Official Transcript of Proceedings
NUCLEAR REGULATORY COMMISSION

Title: ACRS US EPR Subcommittee

Date: November 15, 2011

Presentation to the ACRS Subcommittee

DCS Functional Architecture

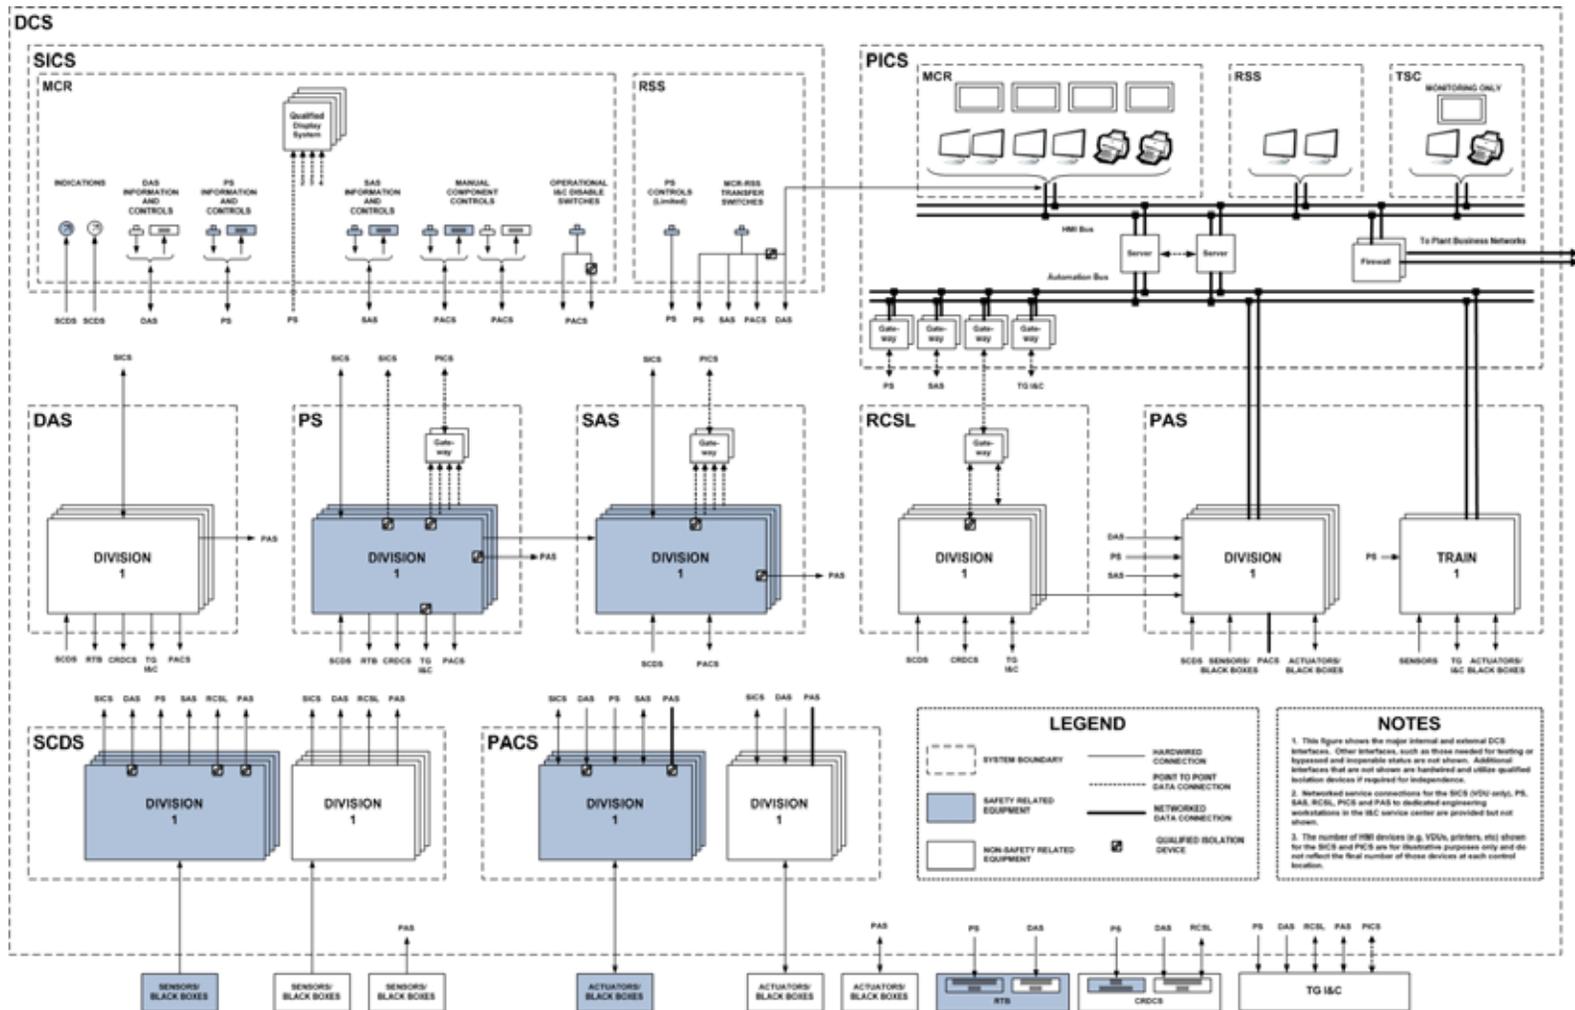
16 MEMBER STETKAR: Jeremy, are you going
17 to talk later, I was kind of thumbing through your
18 slides here and see whether you were, about
19 interactions between PICS and SICS? I had some
20 questions and I don't know exactly where in the flow
21 of things it is best to ask those questions.

18 MEMBER BROWN: The lines going to the
19 RSS, are those -- You don't show the server networks
20 going over towards to the RSS in the SICS
21 arrangement, relative to Protection System controls
22 limited. So are those dedicated lines or are they
23 still coming off the servers or the ability to
24 process?

1 From what I read, I didn't think any of
2 your protection system remote stuff went through the
3 PICS server network system. They go direct but I
4 couldn't figure that out based on -- I was hoping
5 that would be the case but it wasn't very explicit.

5 MEMBER STETKAR: Okay. Then the
6 question is, we talked a little bit about fires in
7 the Main Control Room. This comes from doing fire
8 analysis. Can a fire in the Remote Shutdown System
9 room disable all of PICS? Because it is talking
10 back to the Control Room. If the fire is in the
11 RSS, I'm not going to run in there and open up
12 disconnect switches.

17 The question is, can fire damage in the
18 Remote Shutdown Room call spurious signals that will
19 effectively disable PICS? Not hot shorts in fiber
20 optic cables because they pretty much don't occur
21 but spurious signals because I don't know how those
22 signals are processed. I don't know where the buses
23 are.

6 MR. SHOOK: That's correct. We'll get
7 into more in the further sections. But the PICS
8 cannot send signals to the protection system in SAS.

13 MR. DOYEL: This is Chris Doyel. The
14 fire design basis is that if you do get a fire in
15 the remote shutdown, the Main Control Room would
16 still be available to shut the plant down.

14 But I would say in this case, even if we
15 did lose the PICS, you can still go and shut down
16 the plant from the SICS in that scenario.

Redundancy

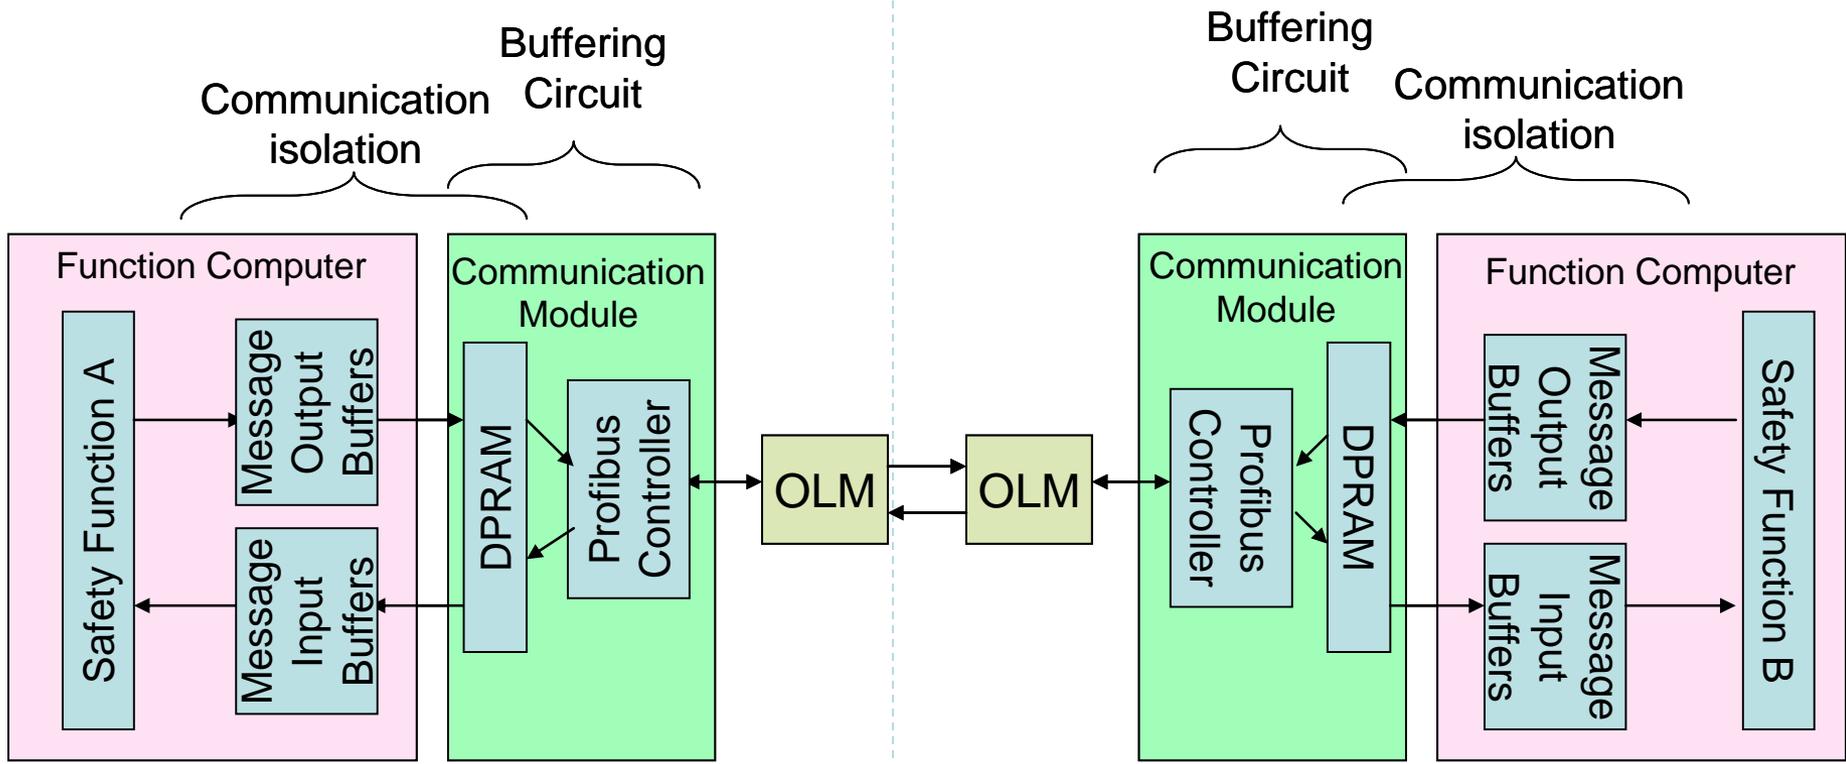
- **SICS, ICIS, EIS, BCMS, RMS, HMS, SCDS, and RPMS**
 - Sufficient level of redundancy: ITAACs
- **Safety Automation System (SAS)**
 - Four redundant, independent SAS divisions
 - Open Item: How does SAS voting logic compensate for single failures within a division? (RAI 505, Question 07.01-36)
 - Open Item: Applicant to provide a FMEA (RAI 505, Question 07.01-35)

Independence

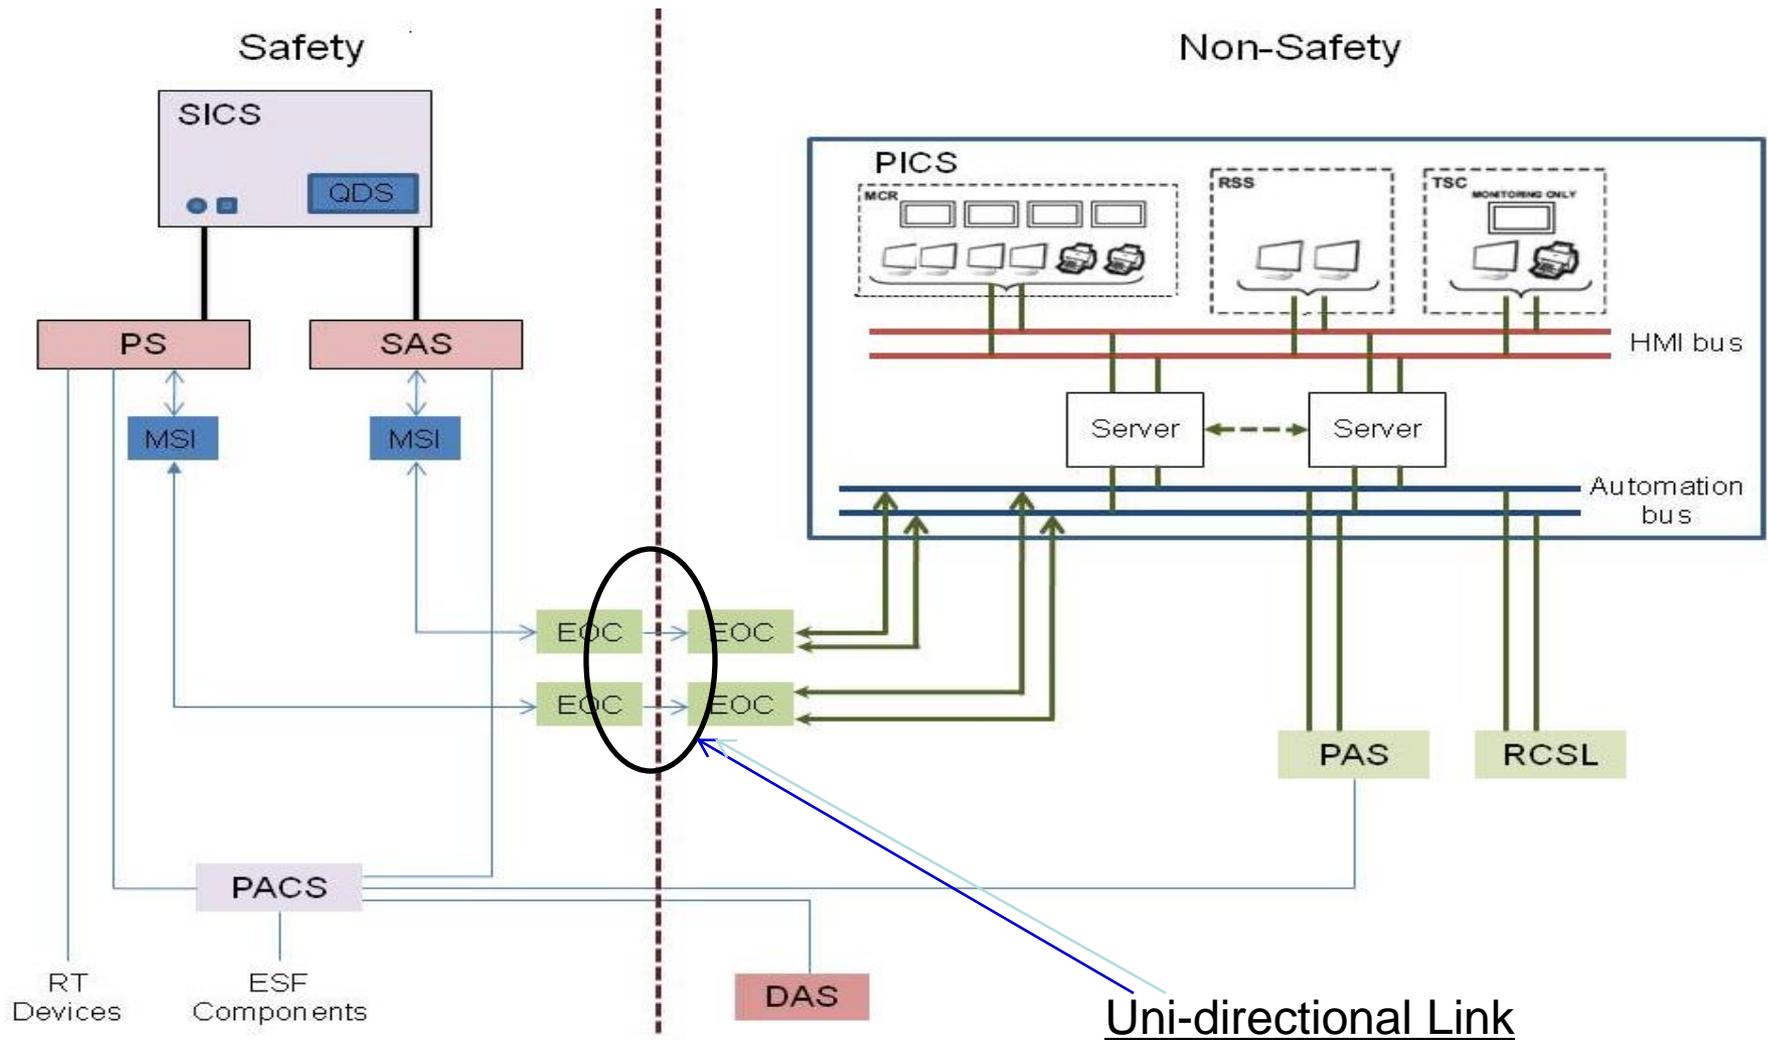
- **Accommodation of SPND Single Failures:**
 - Detection of failures and use of setpoint modification for detected failures
 - Conservative setpoint selection within each PS division to accommodate a single, undetected failure upstream of the PS
 - Open Item: Applicant to submit necessary revisions to Chapter 15 accident analysis and documentation for events crediting use of SPNDs. (RAI 505 Question 07.01-33)

Defense-in-Depth and Diversity

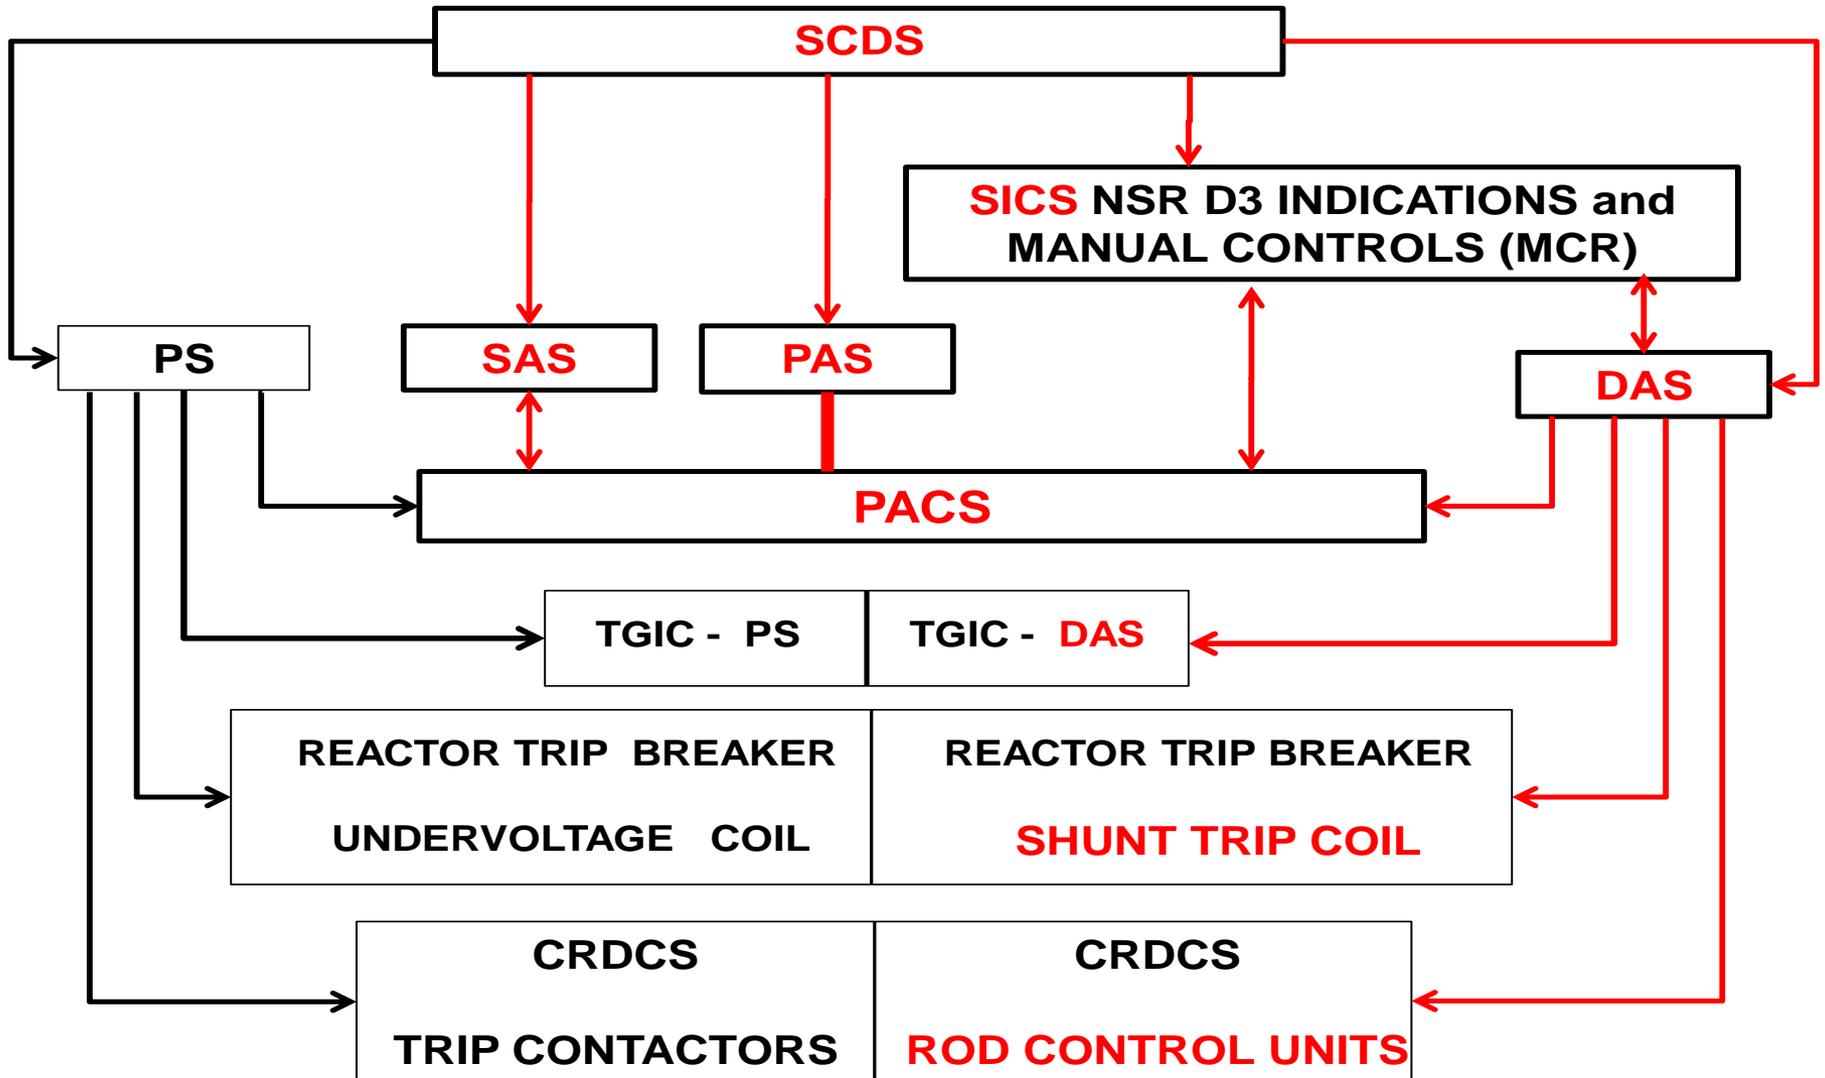
Diversity Attributes	DAS-PS Staff Approved Design Diversity
Design	
different approaches within the a technology	YES
different architecture	YES
Equipment	
same manufacturer of fundamentally different designs	YES
different logic processing equipment architecture	YES
Function	
different purpose, function, control logic, or actuation means	YES
different response time scale	YES
Human	
different designers, engineers, and/or programmers	YES
Software	
	Open Item (RAI 505, Question 07.08-49)

- **Other systems that make up the D3 mitigation systems**
 - PACS: 100% combinatorial testing to address a software common cause failure
 - SCDS: Functions are not performed by microprocessors and there is no software running in the SCDS
 - SICS: Utilizes discrete and analog controls and indications

Self-Testing Open Items

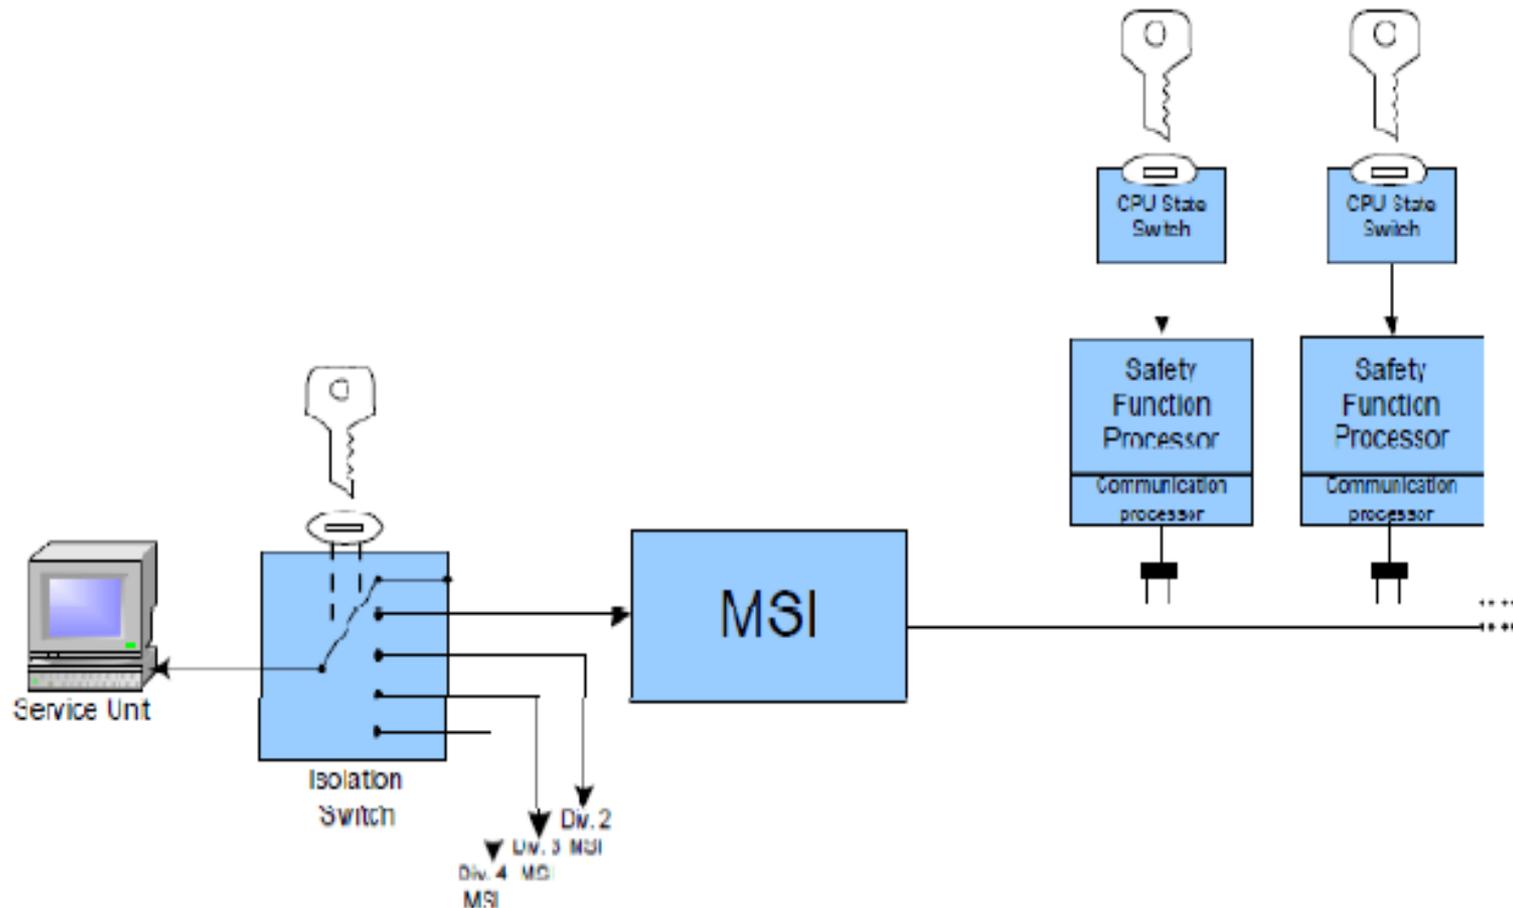
- **TXS Self-Testing and Surveillance Testing**
 - Verification of Self-tests: How is automated self-testing periodically verified? (RAI 505, Question 07.01-39)
 - How is operability addressed for detect failures and failures of the self-test functions itself? (RAI 505, Question 07.01-40)
